M-1978-009 Apache Mine Technical Revision Inert Fill Import Response to Preliminary Adequacy Review for TR-01

Re: M-1978-009 Apache Mine, El Paso County, Colorado
Technical Revision Inert Fill Import Response to Preliminary Adequacy Review for TR-01

Apache Mine
North Pit Map

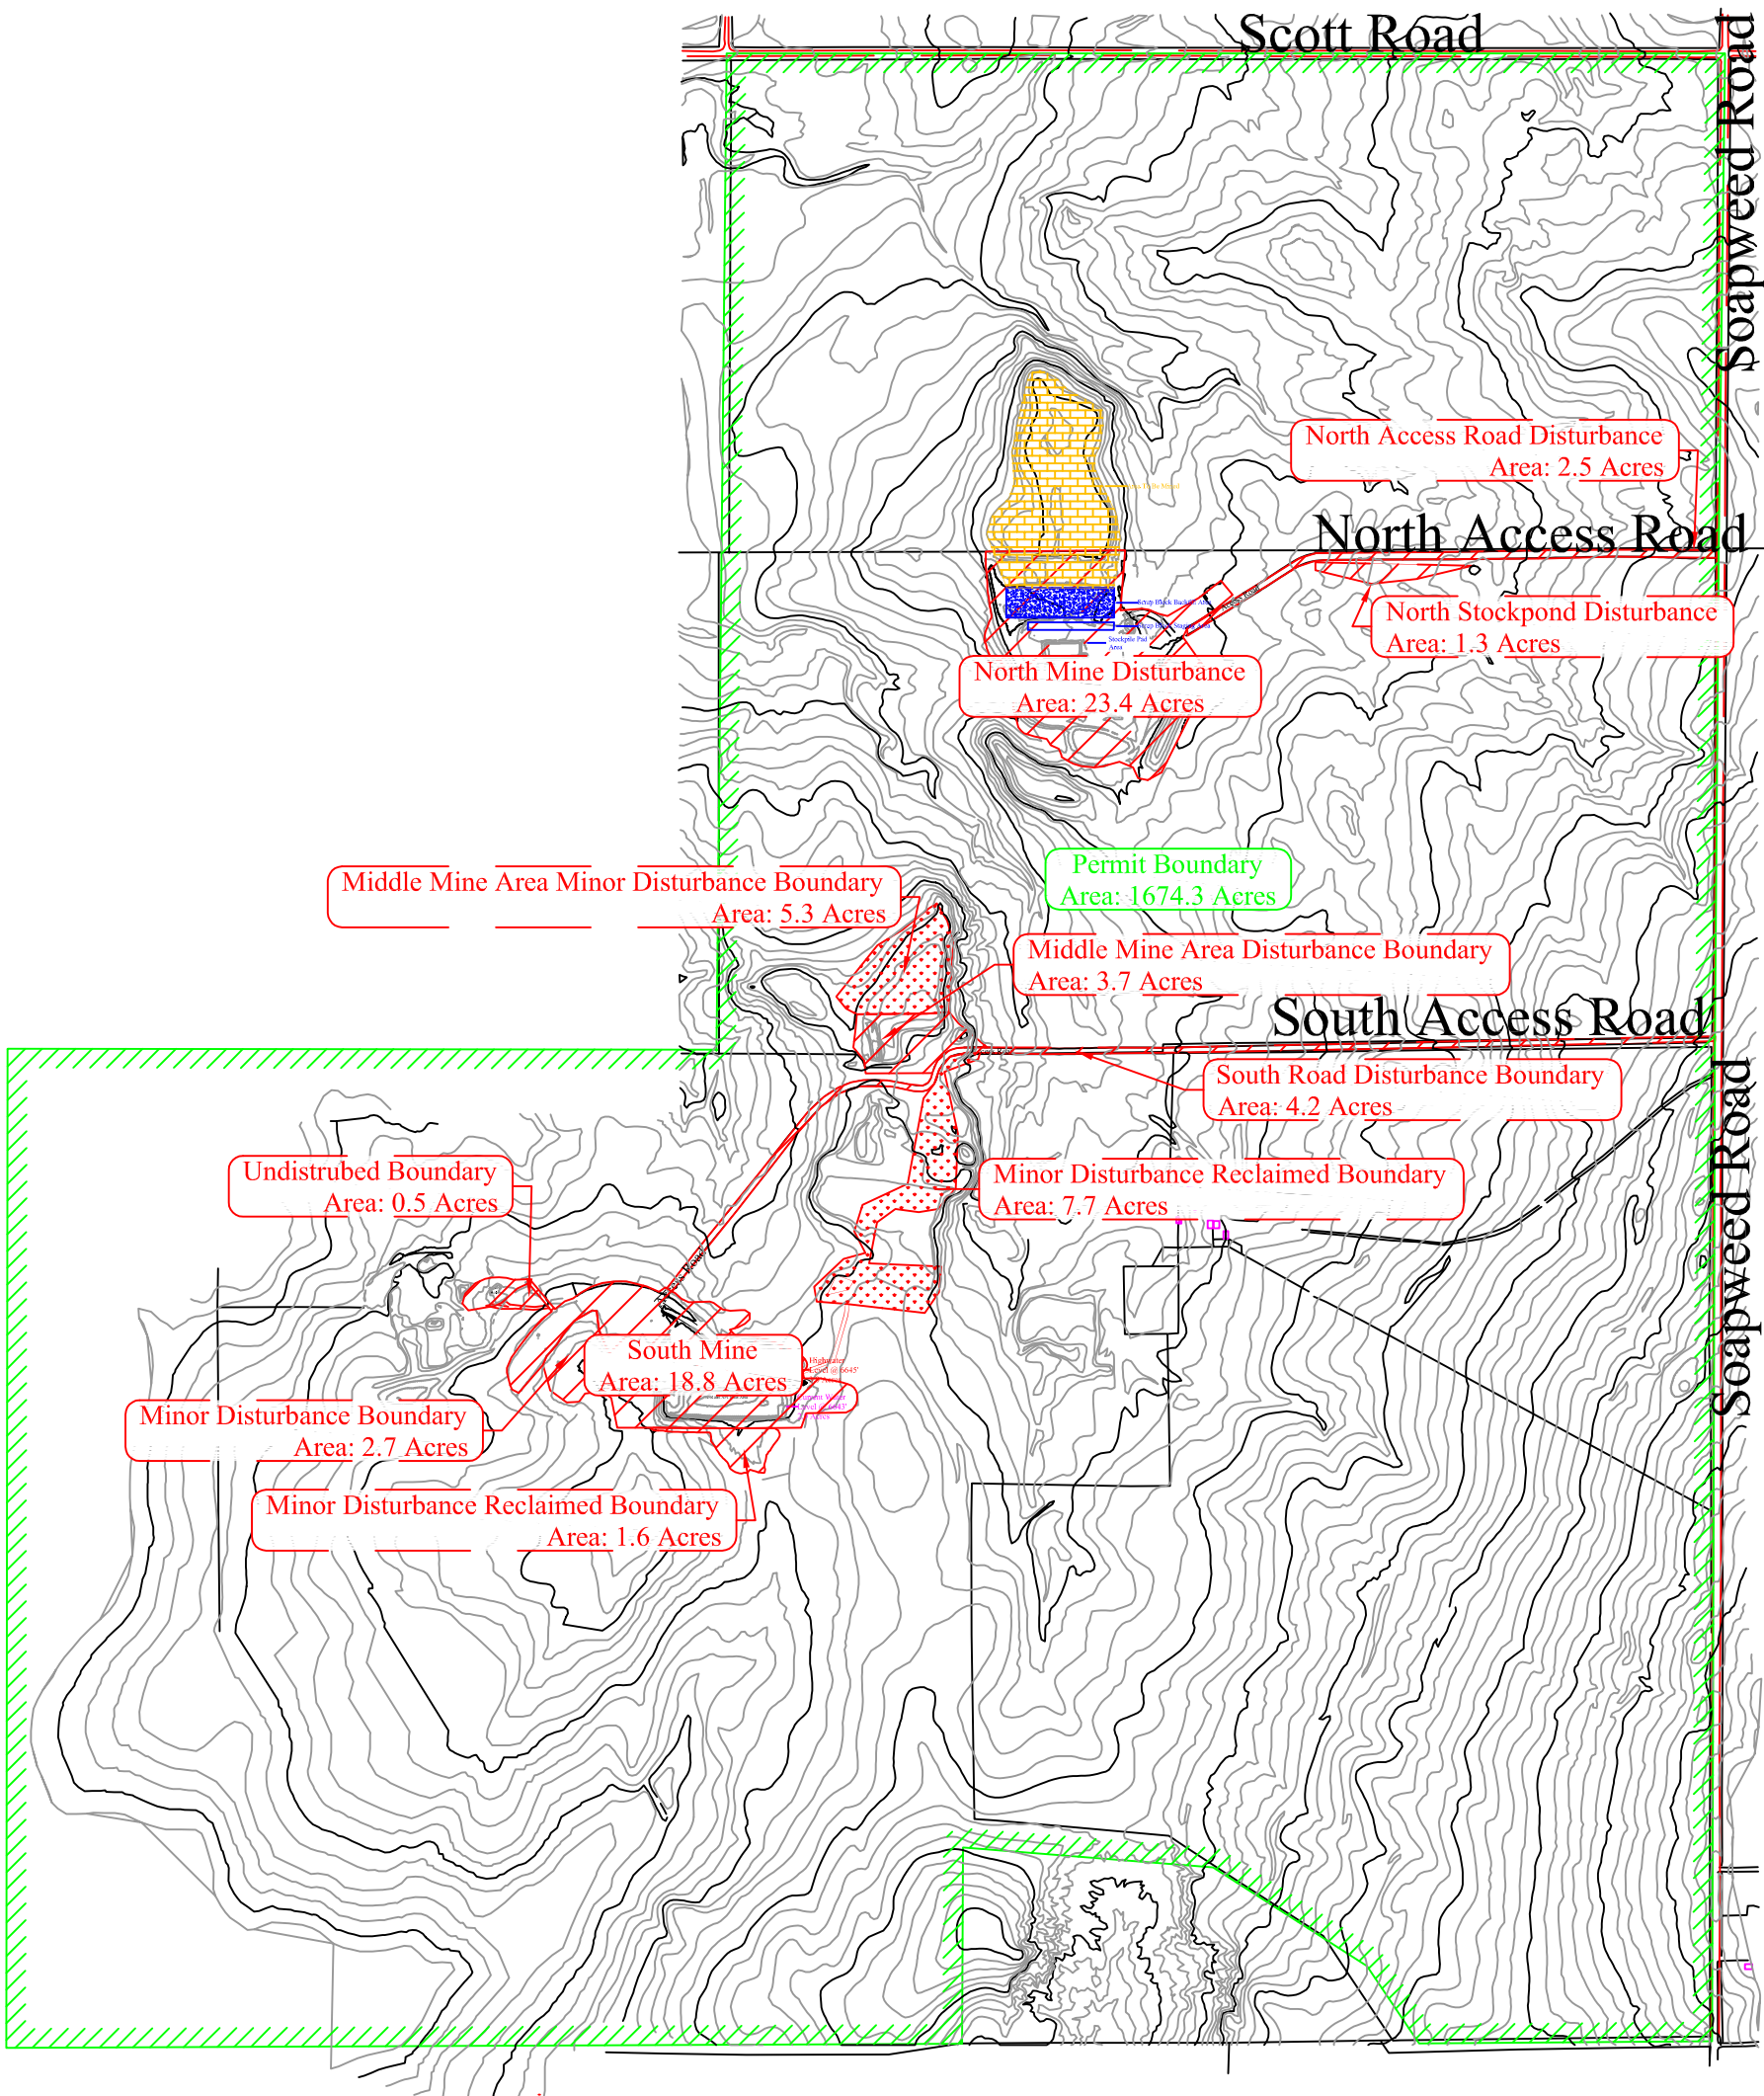
- 1. Please provide a map which depicts the approximate location where the scrap brick and block will be backfilled.***

- 3. The Division is concerned with the potential for sinkholes developing over the long term due to piping where voids occur and/or compaction is sufficient. The formation of sinkholes is not considered compatible with the approved rangeland post-mining land use (reference Rule 3.1.5(9)(e)). Per Construction Materials Rule 3.1.5(9)(f), please provide additional detail on how the scrap brick will be blended with overburden material so that settling of the backfilled area does not occur. In addition, describe how compaction of the backfilled material will be achieved.***

The materials will be placed in the north pit at Apache. Please see the attached maps named Apache Mine Site Map and Apache Mine North Pit Map.

The materials will be placed at the floor of the previously mined out pit in 1-2 foot thick layers, see attached Apache North Pit Map. The loader, with a full bucket, will wheel roll each 1-2 foot thick layer until the materials are tight, meaning the tires sink 1-2 inches into the fill based on visual inspection of the fill. If necessary, the loader operator may add water to the fill to assist with compaction. Additional 1-2 foot thick layers will be built on top of the previous layers until the bench matches the elevation of the clay stockpile pad area.
